**RE: 419 S. Pine Ave
Response to Village Comments
Haeger File No.: 24-042**

Haeger Engineering ("Haeger") is in receipt of your review comments dated April 9, 2024. We have revised the submittal materials accordingly per the comments. The original review comments are included below, shown in *italics*, with our responses to each comment followed in **bold**.

419 S. PINE AVENUE TWO-LOT SUBDIVISION SUBDIVISION IMPROVEMENT PLANS

EXISTING CONDITIONS & DEMOLITION PLAN
419 S. PINE AVENUE
TWO-LOT SUBDIVISION
 LANDMARK CUSTOM HOMES

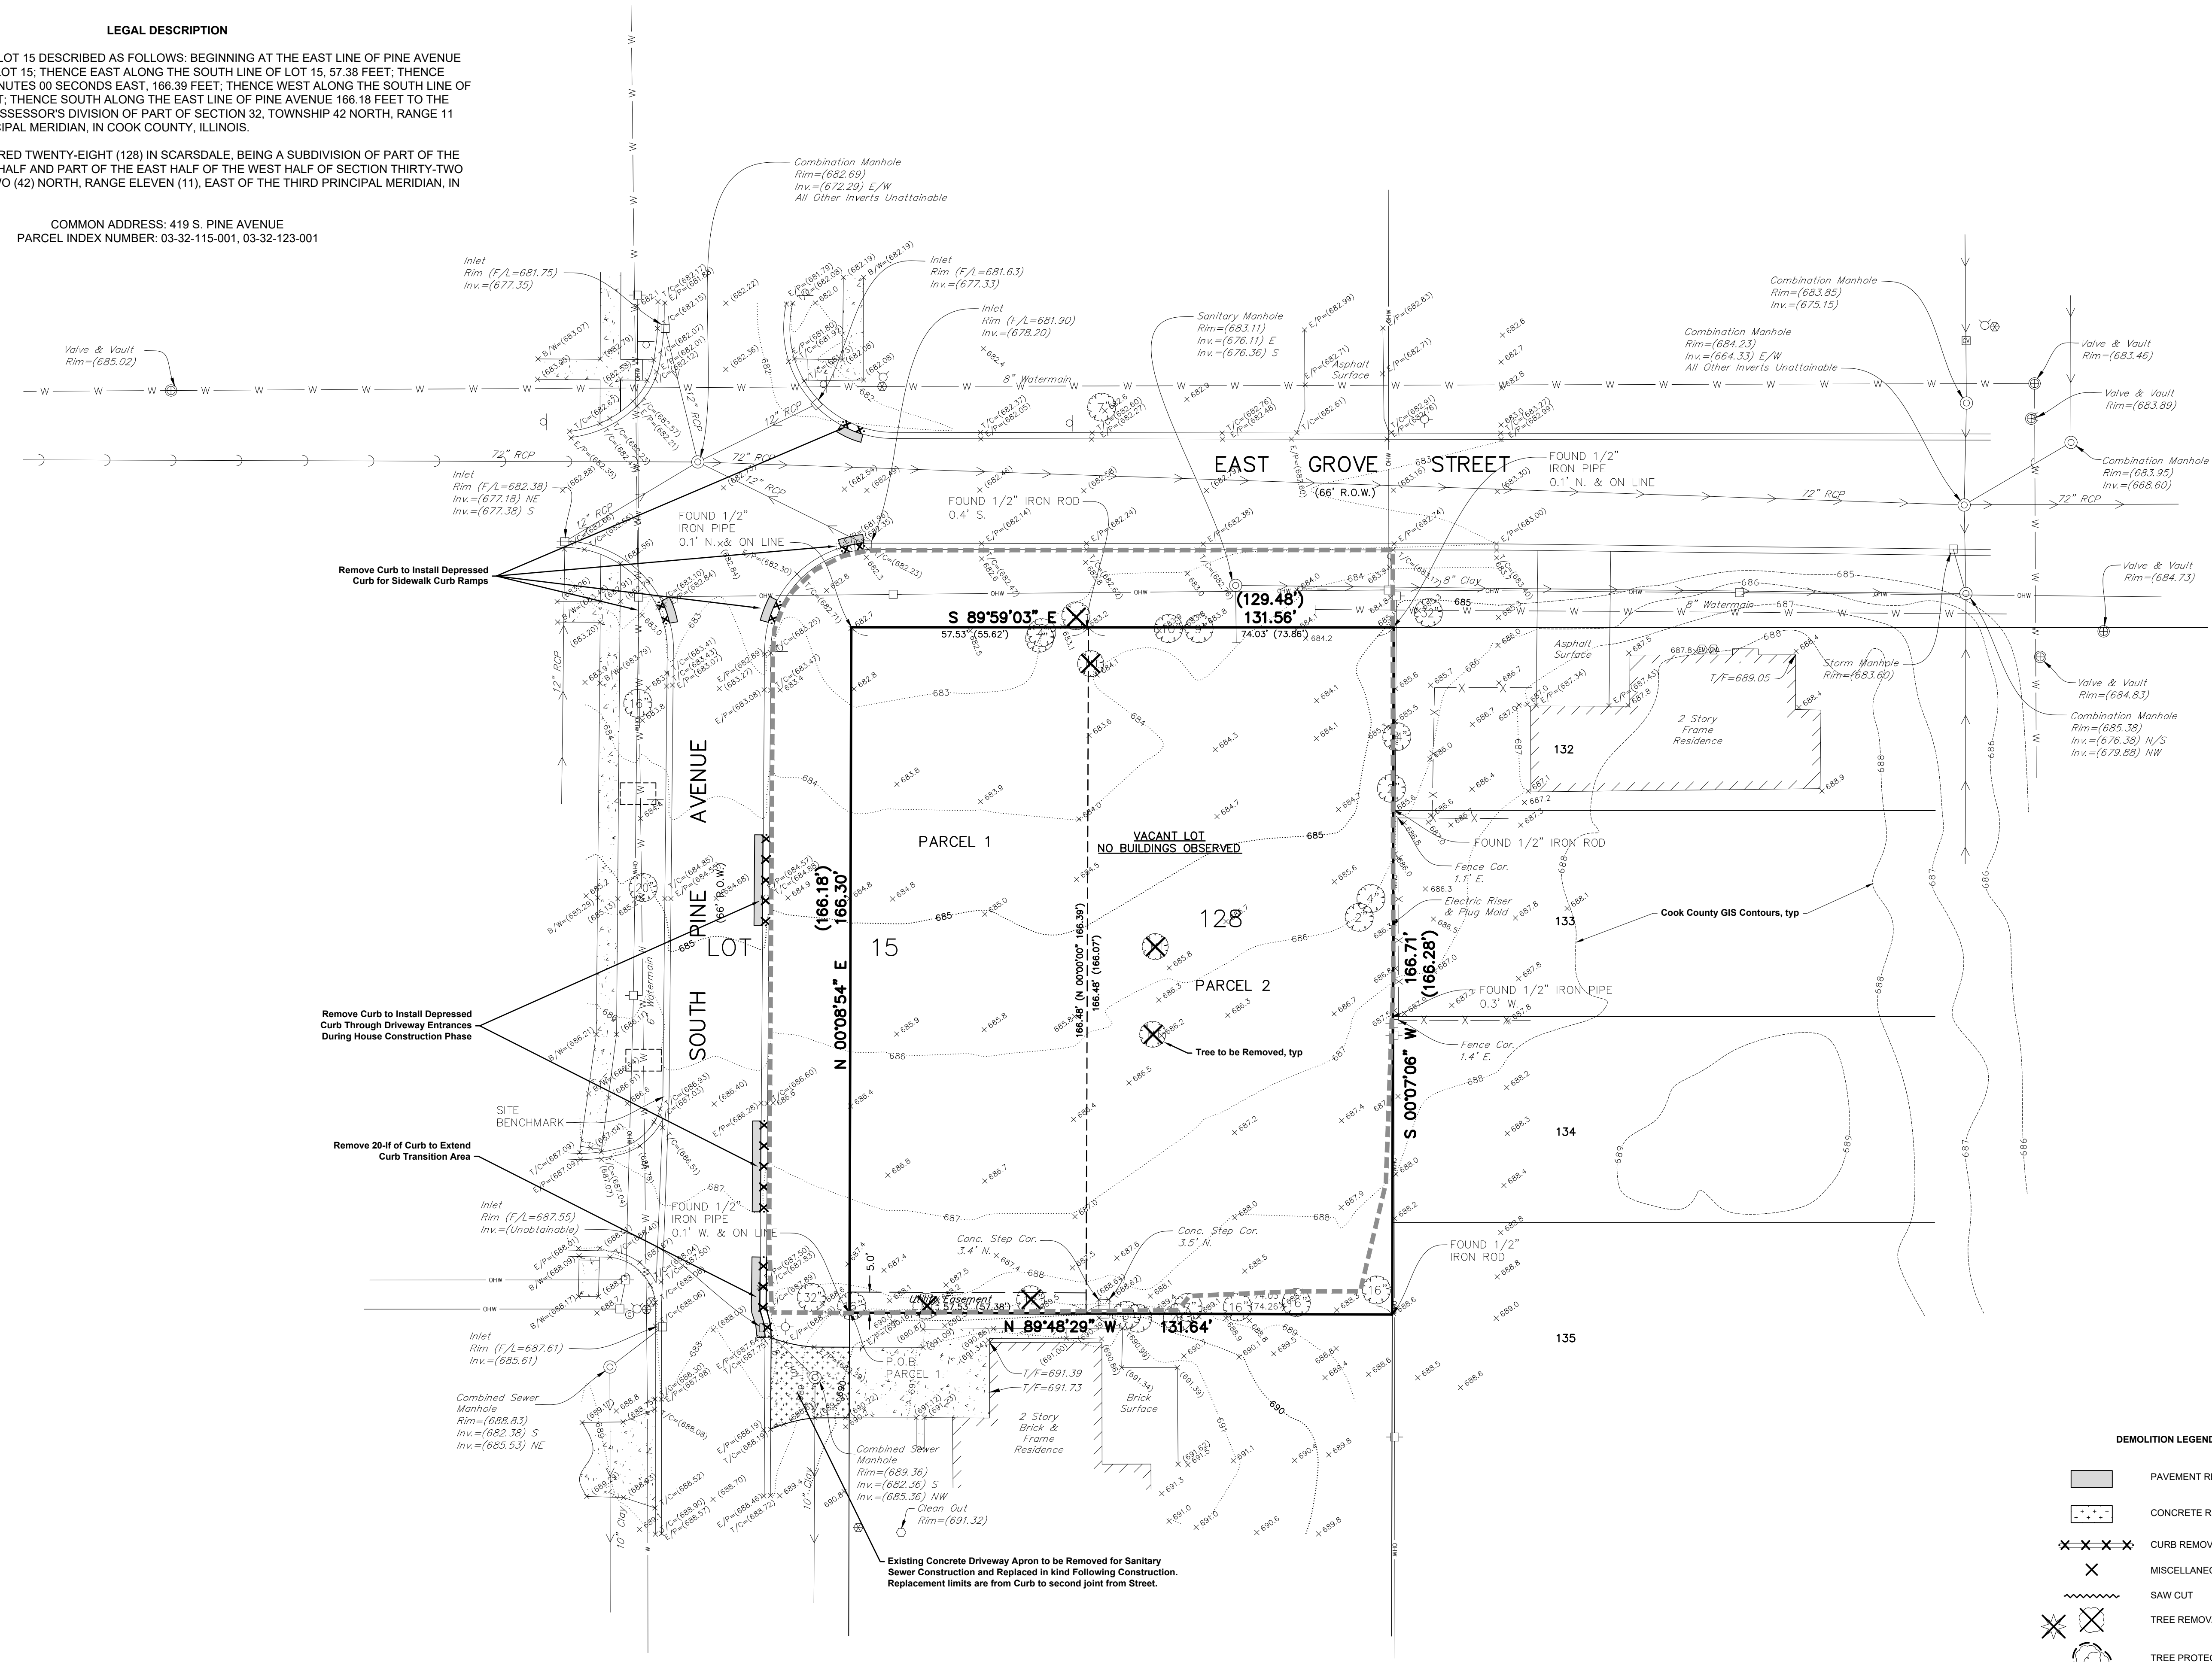
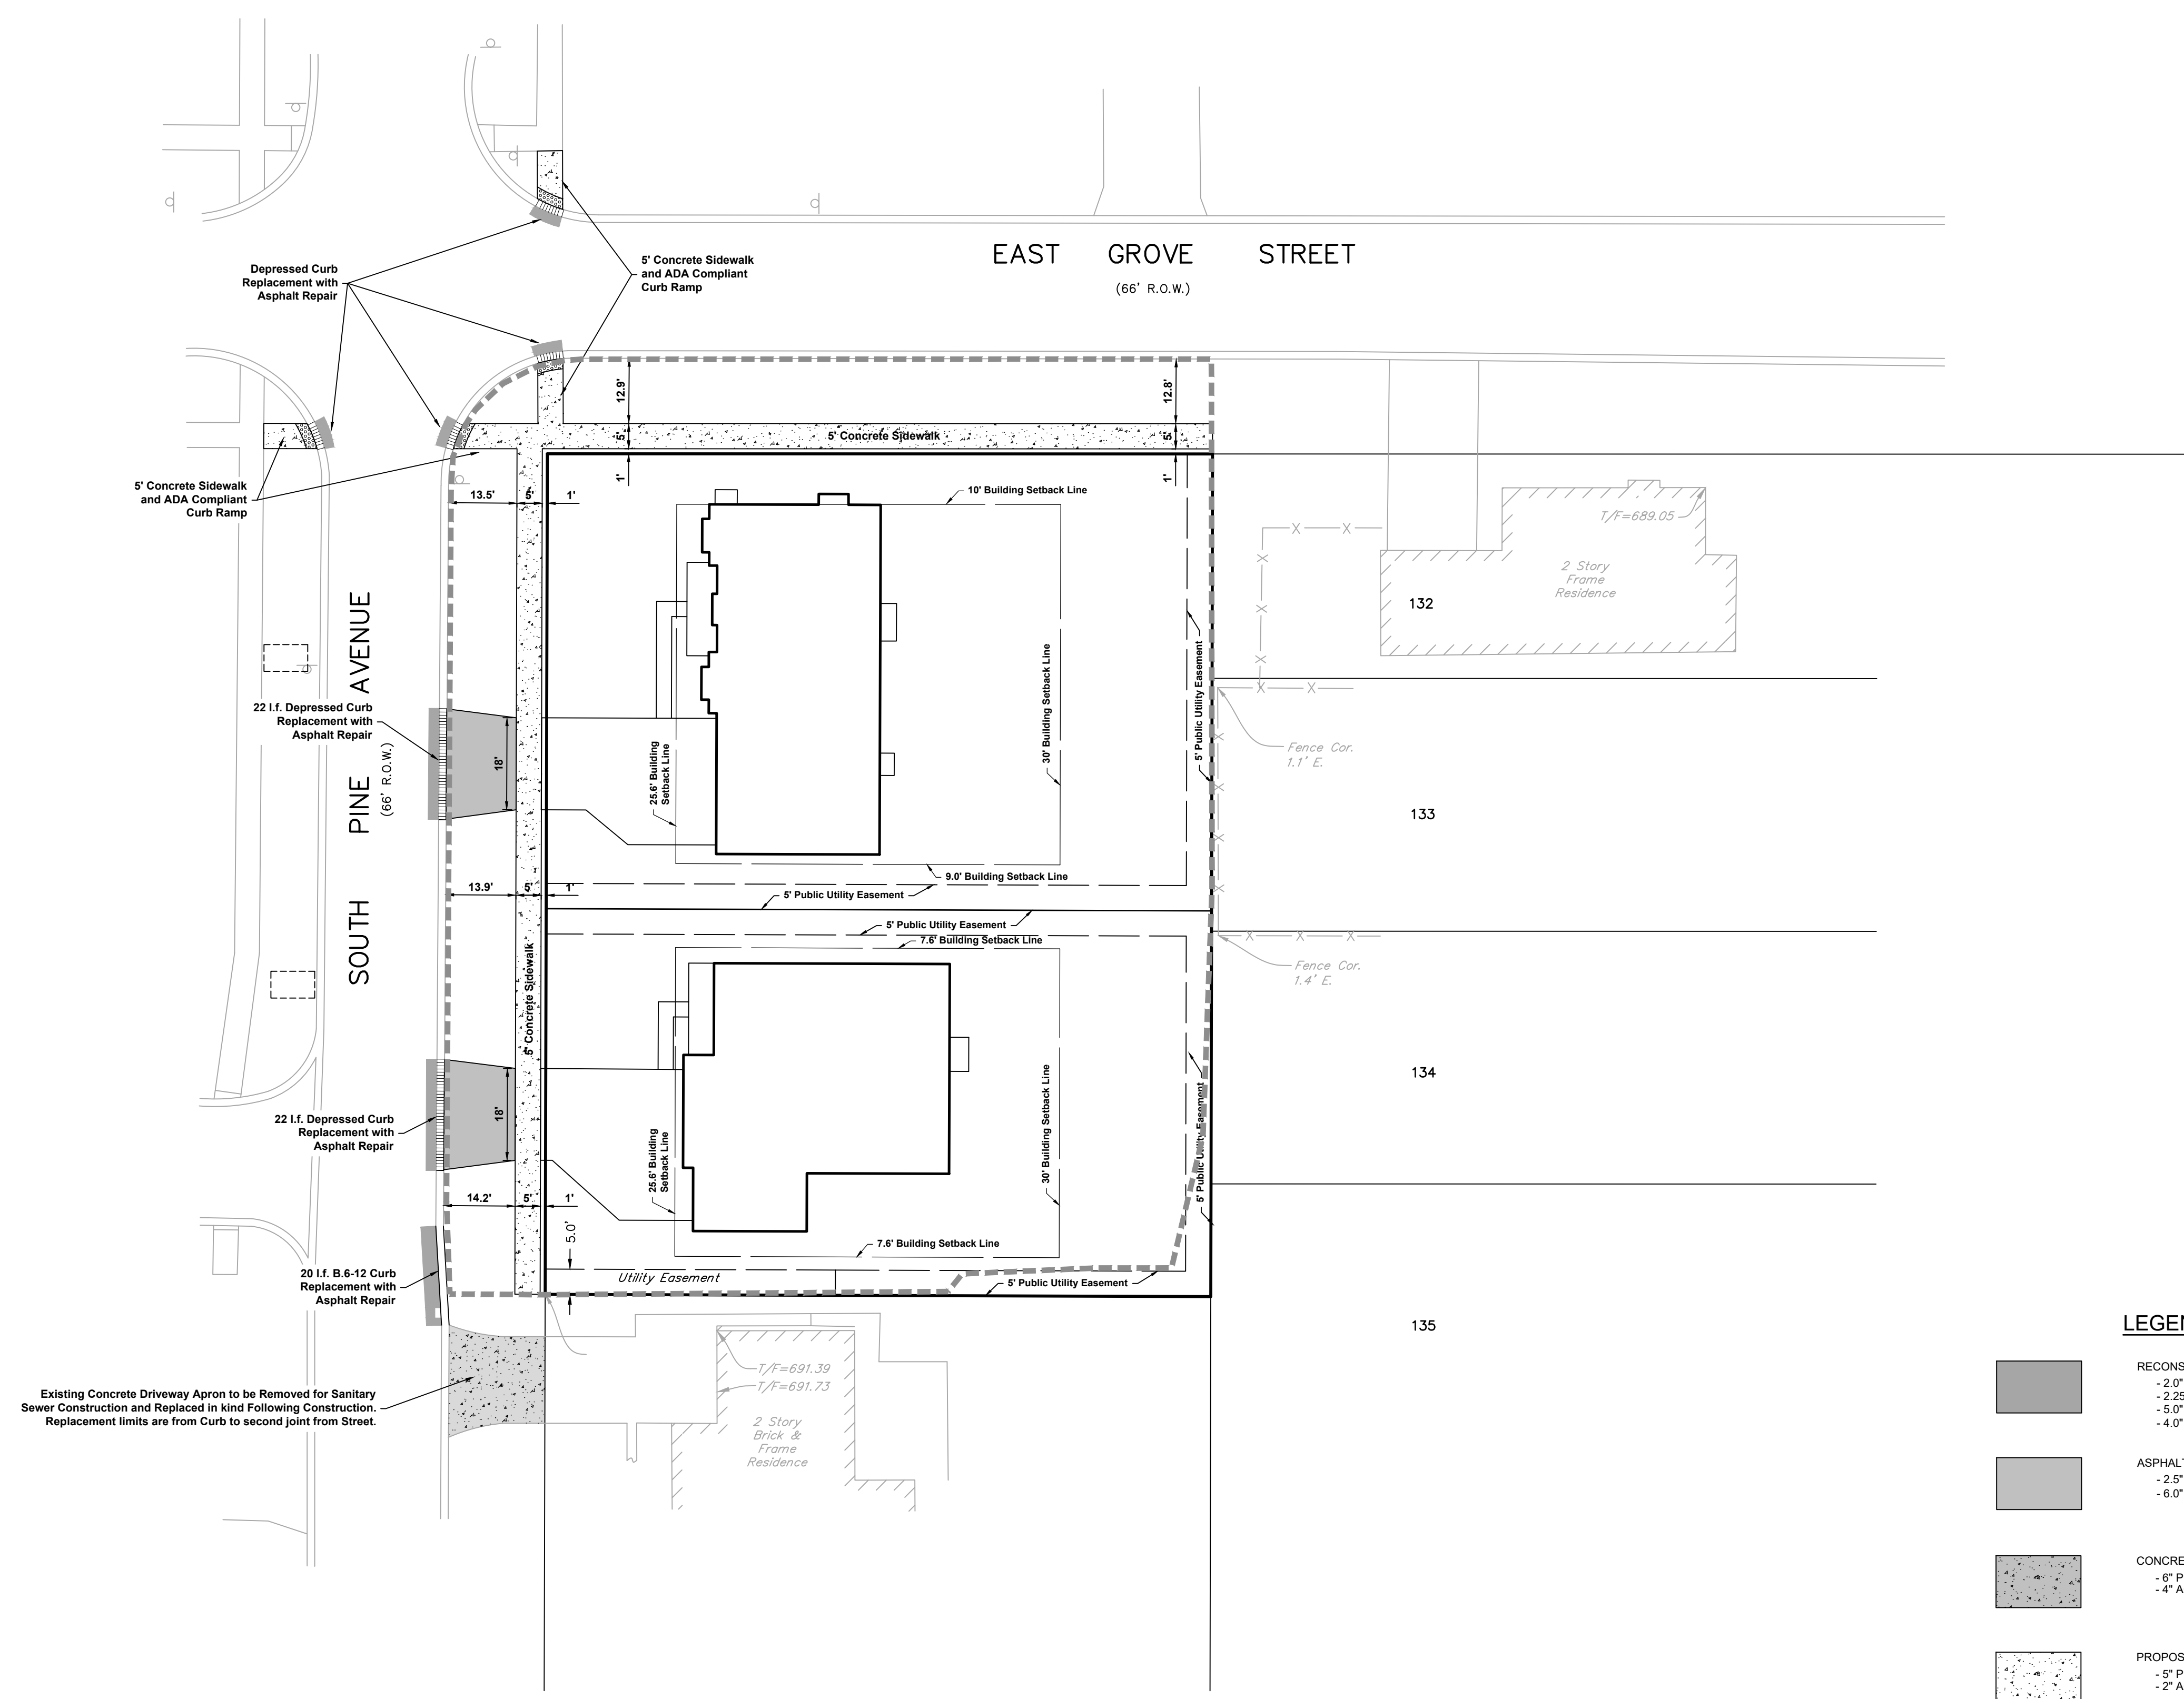
25. Provide additional information to evaluate the existing drainage patterns for the rear yards for 406 and 410 S Belmont Ave.

Additional off-site contour elevations have been added to Sheet C3.
